Agenda – Appeal Committee – April 20, 2026

Item No. 2 Appeal – Variance – 595 Gertrude Avenue
(Fort Rouge-East Fort Garry Ward)
File DAV 262235A/2025B

Title: DAV 25-262234\B – 595 Gertrude Ave

Issue: For consideration of a Variance associated with increased fence height.

Figure 4: Fencing along the west property line.

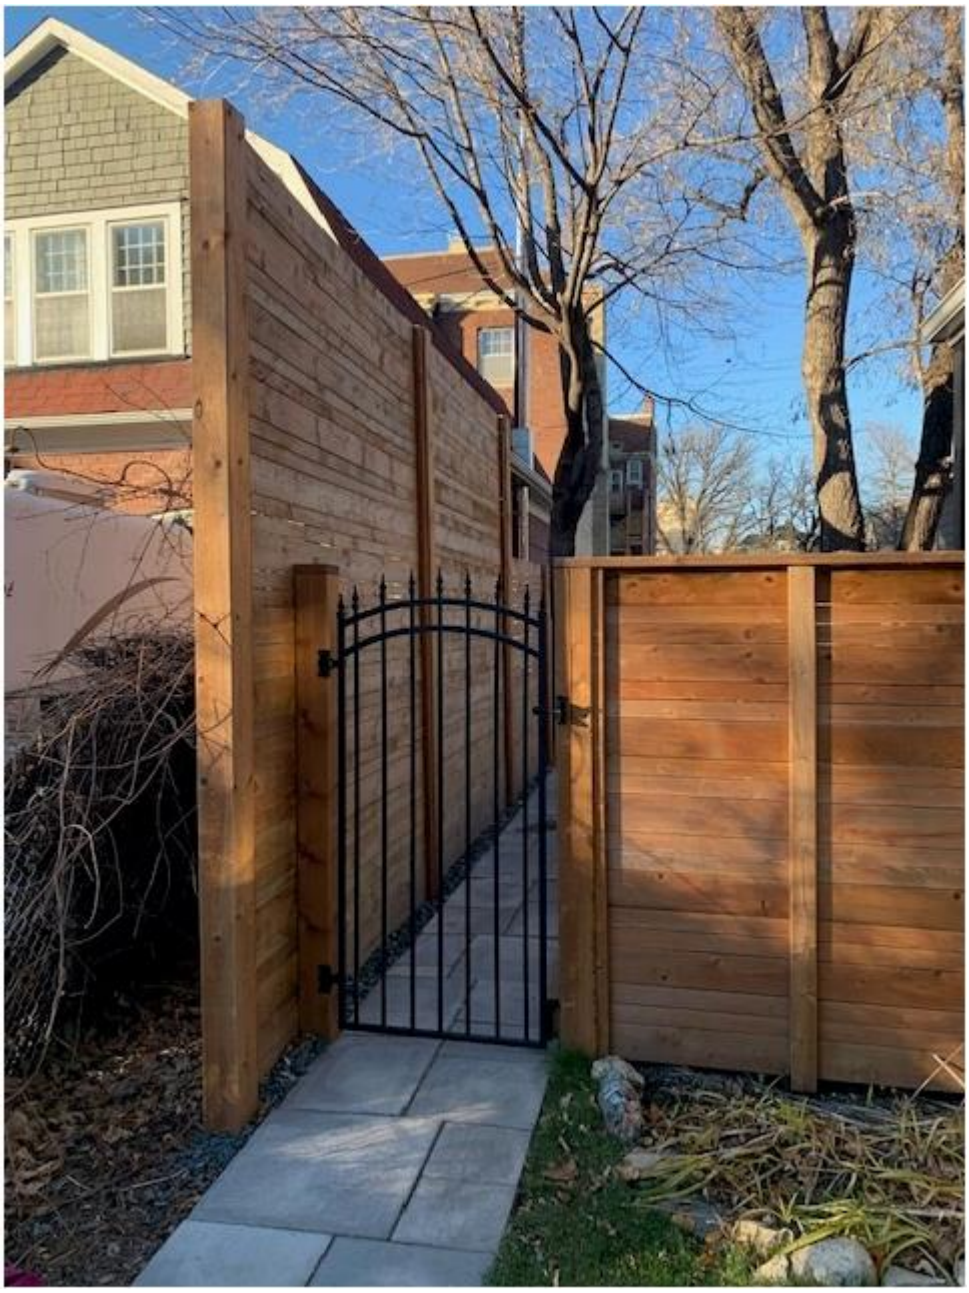
The increased height of the existing fencing is not compatible with the dwelling or existing fencing on the block and poses a substantial adverse impact upon adjoining properties and the adjacent area.

The existing fence heights far exceed the by-law regulations and what would be supported by Urban Planning. In 2023, the applicant worked with Urban Planning to arrive at a compromised height of 7.5 feet and the applicant advised that they would reduce the fence height accordingly. Further inspections at the site reveal that the applicant did not complete the necessary reduction to the fence height to meet the supported and approved height of 7.5 feet.

If the applicant feels that they require more privacy than they previously were granted via the Variance order from 2023, they can construct some type of lattice like structure that can then be covered in some type of vegetation, in the buildable area of their property. This option would not require a Variance for height so long as it did not exceed 13 feet.

Sheet Name:
PRIVACY SCREEN
LOCATION LAYOUT

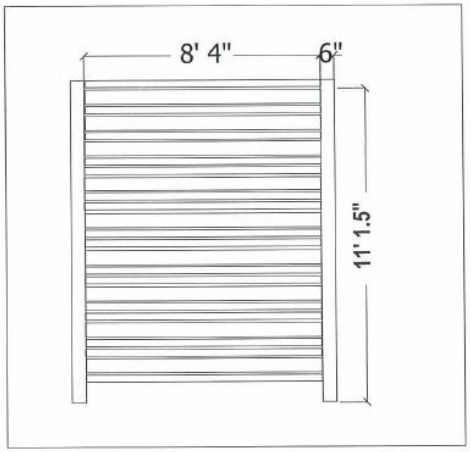
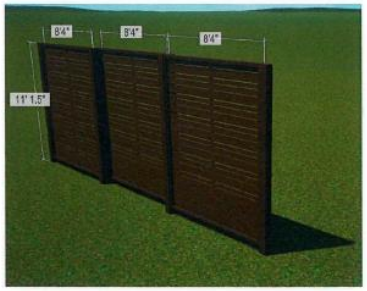
The applicant intends to maintain the existing fence height of 11.3 feet along a portion of the west side yard and a fence height of 8.09 feet along the rear yard. For these reasons, a Variance is required.
